International Isotopes Inc.

April 05, 2012

Subject: Response to Request for Additional Information - Amend NR-1235-S-101-S.

The following additional information is provided to support my November 29, 2011 letter requesting an amendment to Sealed Source and Device Registration (SS&DR) NR-1235-S-101-S. I have duplicated your questions before each of my responses.

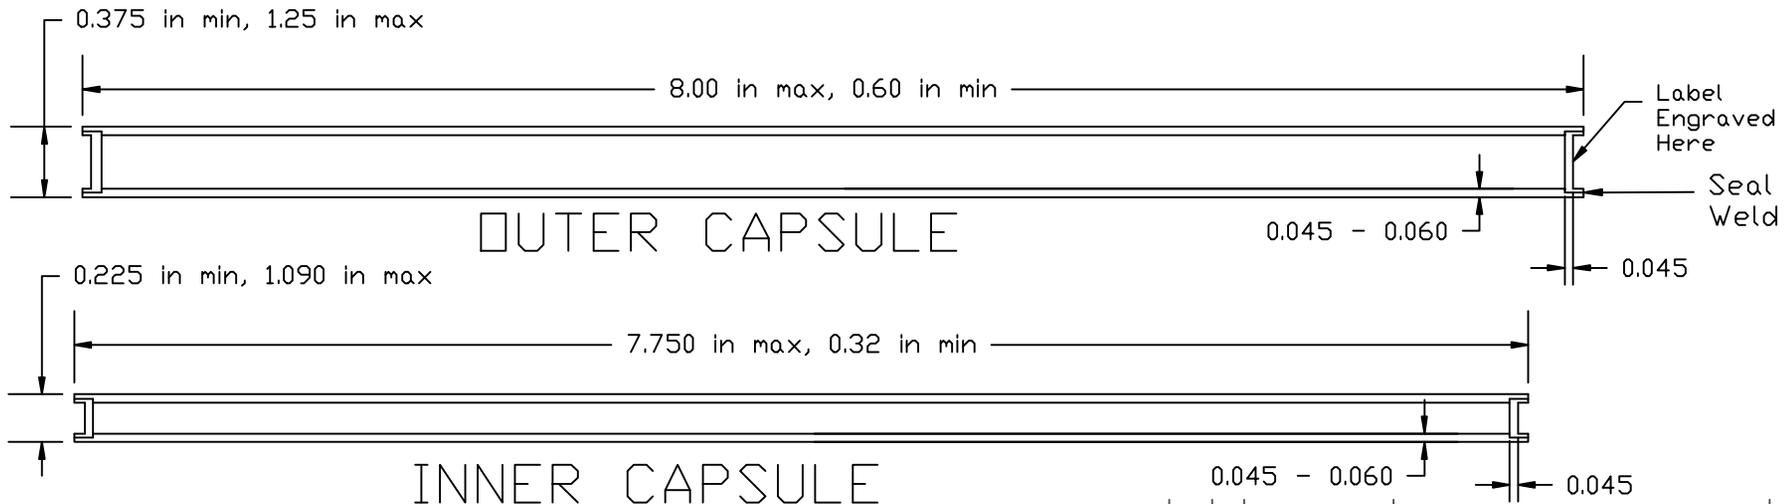
RAI 1.1 Please clarify the wall thickness tolerance requested. With respect to the wall thickness tolerance provided in your request (0.045 + 0.020 / - 0.005 in) - could you provide a drawing and description that specifies exactly what the new wall thickness design is?

Are the changes in wall thickness to both capsules (i.e. inner and outer capsules) and both methods of source capsule fabrication (i.e. single and double end cap design)? Please provide a drawing that includes the new wall thickness tolerance.

After submitting the request to amend NR-1235-S-101-S I realized that the range in wall thickness tolerance could be confusing. It would have been better to maintain the wall thickness tolerance at ± 0.005 inches and instead define a range for wall thickness. In lieu of revising NR-1235-S-101-S to indicate wall thickness as $0.045 + 0.020 / - 0.005$ inch I believe it is more appropriate, and achieves the same dimensional range, to indicate wall thickness as $0.045 - 0.060$ inch ± 0.005 inch.

The sidewalls **range from 0.045 to 0.60 inches** ± 0.005 inches thick.

As mentioned in the request, the purpose of increasing the wall thickness is to narrow the active source diameter without adding a sleeve. The active source dimensions are solely a function of the inner capsule. I would however like to apply the wall thickness revision to both the inner and outer capsule, as there may be a customer in the future that requires a source that has thicker inner and outer capsule walls.

Revised Drawings, INIS-DWG-0001 REV C and INIS-DWG-0002 REV C are enclosed as requested.
